Application for Amendment of Plan Under Section 12A of the Town Planning Ordinance (Cap.131) for Proposed Residential Development and Social Welfare Facility (Child Care Centre) at Various Lots in D.D. 128 and D.D. 129, and Adjoining Government Land, Lau Fau Shan, Yuen Long, New Territories (Planning Application No. Y/YL-LFS/14)

We refer to the comments from various Government departments on the captioned S12A Planning Application received between 11 April 2024 and 12 June 2024.

Application for Amendment of Plan Under Section 12A of the Town Planning Ordinance (Cap.131) for Proposed Residential Development and Social Welfare Facility (Child Care Centre) at Various Lots in D.D. 128 and D.D. 129, and Adjoining Government Land, Lau Fau Shan, Yuen Long, New Territories
 (Planning Application No. Y/YL-LFS/14)
Responses to Comments

Indicative Hammerhead for the Proposed Layby

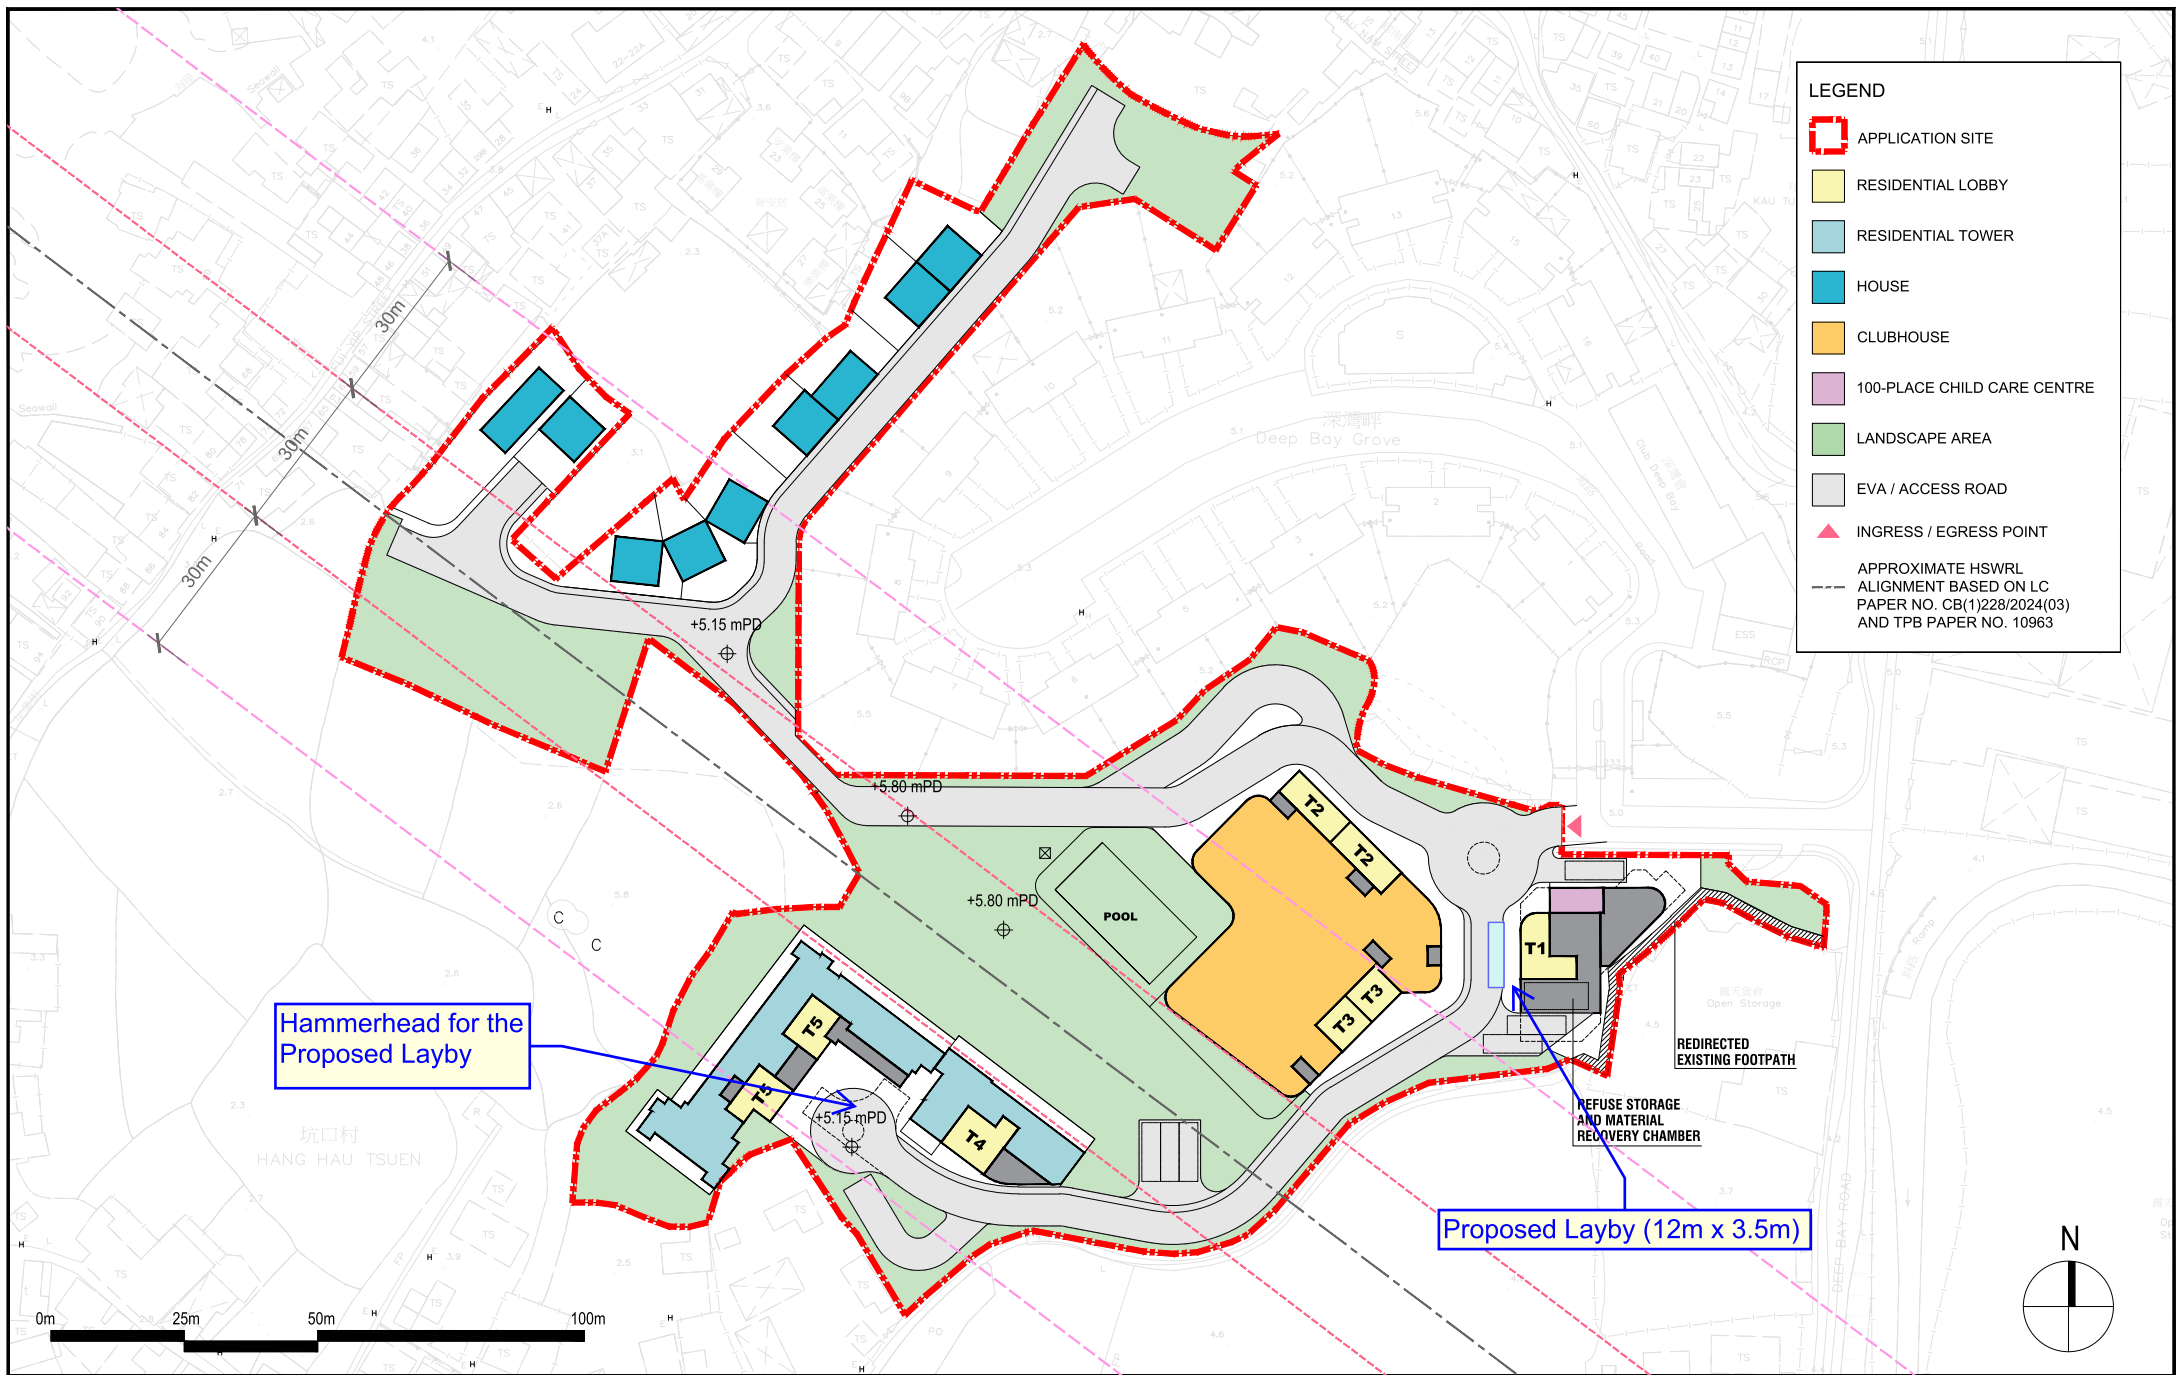
No.	Comments	Responses
	<p>please clarify whether the population and employment in the intensified HSK/HT NDA have been taken into account. Furthermore, please clarify if LATM are used in your assessment.</p> <ul style="list-style-type: none"> - In Section 3.2.2 of Annex E, please consult HyD on the latest progress of PWP Item No. 6878th(Part) regarding widening of Deep Bay Road. - Annex F: With reference to the mode hierarchy and the similar arrangement for LFS transitional housing, the nearby GMB services (serving Deep Bay Road) and MTR feeder bus services would be enhanced, subject to passenger demand. In this connection, the proposed layby (12m X 3.5m) within the development should be reserved for the prospective GMB services, with flexibility for operation of other types of services (e.g. shuttle bus) only if no relevant public transport services were available. In any case, the exact plan for the transport services is subject to TD's further assessment and review, with due consideration to the development and planning of the transport system/services in the LFS area near the time. - Annex F: Please indicate the turnaround facility for the proposed layby. 	<p>New Development Area”, the Hung Shui Kiu/Ha Tsuen New Development Area (HSK/HT NDA) will be developed in phases. Phase 1 and Phase 2 developments are scheduled to be completed by 2032 whilst the Phase 3 development is scheduled to be completed in 2037/2038.</p> <p>Phase 1 and Phase 2 developments of HSK/HT NDA would be completed before the design year 2036 and has been considered in the traffic forecast. Nevertheless, taking into consideration that the Phases 1 & 2 developments are not in close proximity to the identified study area, their traffic impact would be limited on the identified study area. Therefore, the 2036 reference traffic flows were derived by adopting appropriate growth rates onto the observed traffic flows, instead of using the LATM.</p> <p>Advice from HyD on the latest progress of PWP Item No. 6878th(Part) - widening of Deep Bay Road has been sought. Please find attached the reply email from HyD in Annex E for your information.</p> <p>Noted. The proposed layby (12m X 3.5m) within the development will be reserved for the prospective GMB services, with flexibility for operation of other types of services (e.g. shuttle bus) only if no relevant public transport services were available.</p> <p>The hammerhead for the proposed layby is illustrated in Annex F. Details of the</p>
